**TOWN OF WINTER PARK
PLANNING COMMISSION
Tuesday, April 26, 2022 8:00 AM**

TO Planning Commission
FROM Hugh Bell, Planner
THROUGH James Shockey, Community Development Director
DATE April 26, 2022
RE Single-Family Detached Design Review – Lot 12A, Whiting Tracts – 499 Kings Crossing Road (PLN21-126)

TO Planning Commission
FROM Hugh Bell, Planner
THROUGH James Shockey, Community Development Director
DATE April 26, 2022
RE Amendment to Design Review Single-Family Attached – Lots 9-18, Block 5, Roam Subdivision Exemption No. 3 – 13-49 Ski Idlewild Road (PLN20-045)

Excerpt from elevations approved at 08/11/2020 Planning Commission hearing

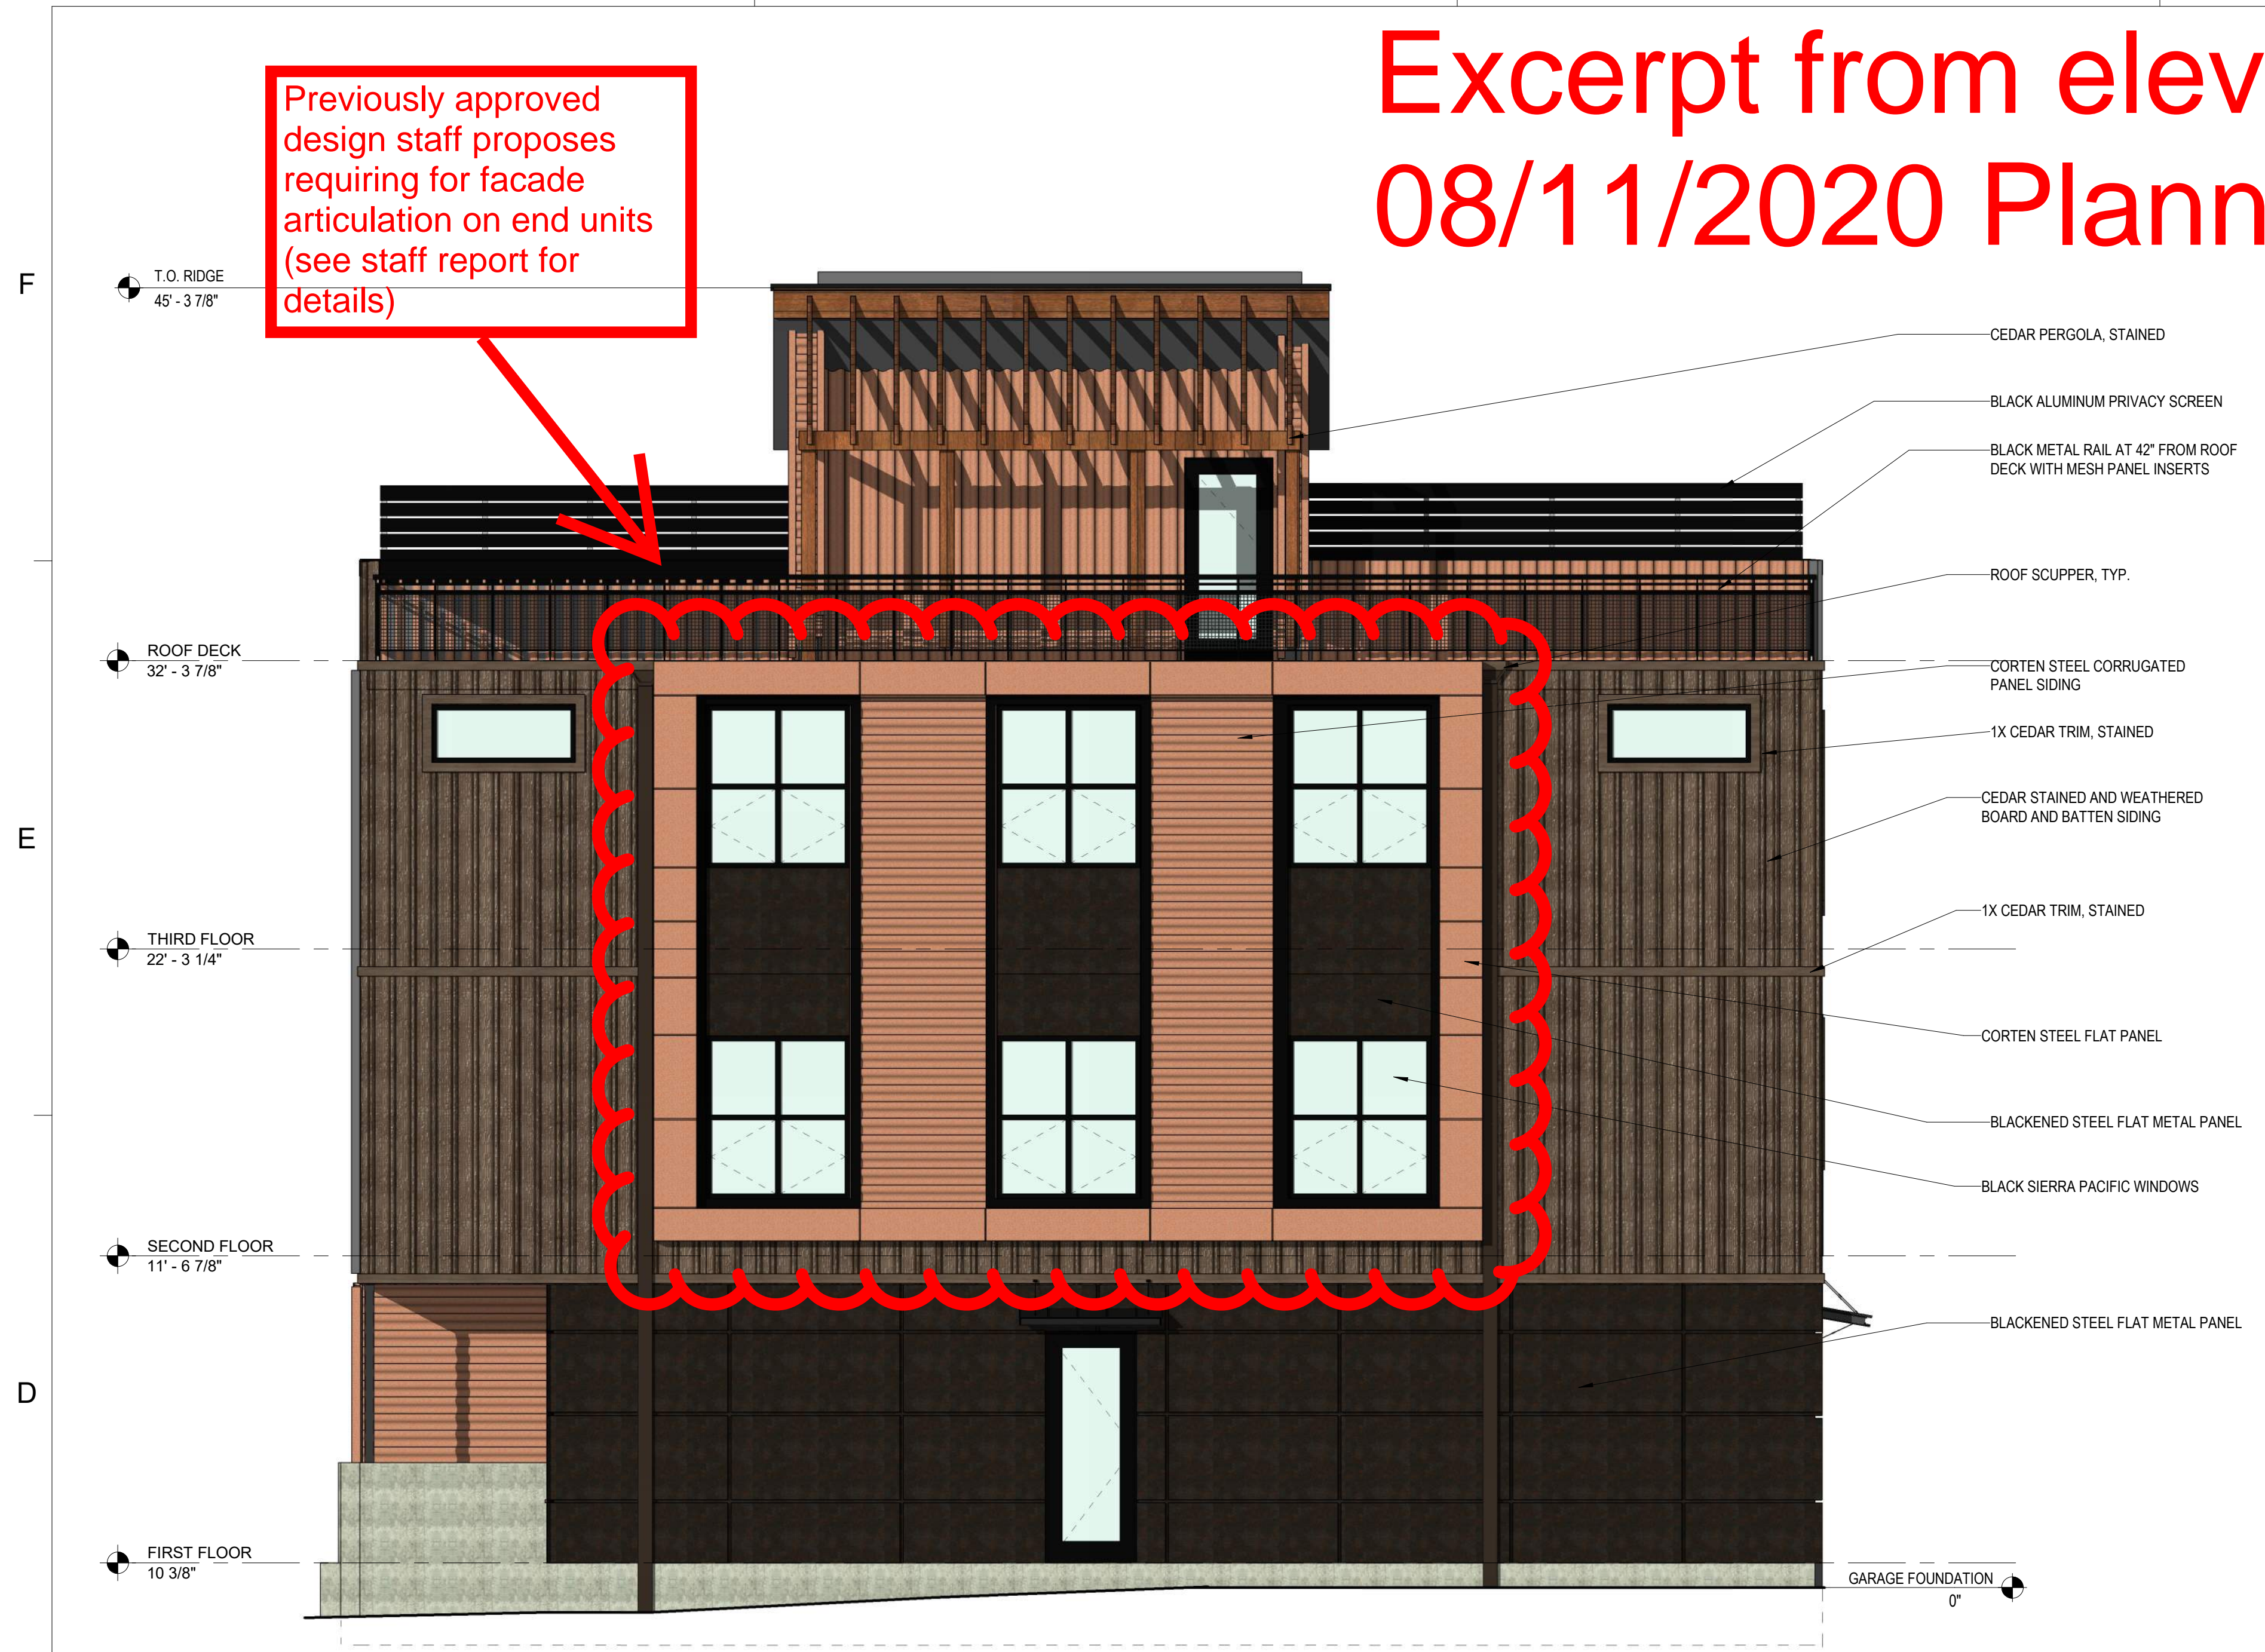
The first request is for the variance of the blackened copper metal panels at the first level of the 10 buildings on Lots 9 through 18. The original plans called for 32" tall by 60" long panels placed in a horizontal pattern, from corner to corner.

The metal panels that are currently in place are the same approved material (blackened copper) and installed in a horizontal pattern as originally planned, but are smaller in size, being 18" tall. These panels are also 8' long in an effort to align with other vertical components of the building (i.e. gas lines, downspouts, windows).

The reduction in metal panel height is a result of the manufacture ceasing production of any panel taller than 18". The 18" tall panel was the tallest panel available from the manufacturer, so that is what was used.

The second variance request is for the metal accent siding at the north exterior wall of the second level of Lot 9 and the south exterior wall of the second level of Lot 18. The siding crew was provided the plans with the accent metal siding pattern and provided instructions on where to install each finish material, namely the rusted Corten and blackened copper metal panels. There was miscommunication with the siding crew and they installed the materials in a different configuration, that is in place now. The requested variance, if approved, would maintain the current look of what is currently in place.

Paint all existing “blackened copper” panels black, and end unit frame detail will be all vertical corten corrugated panel.
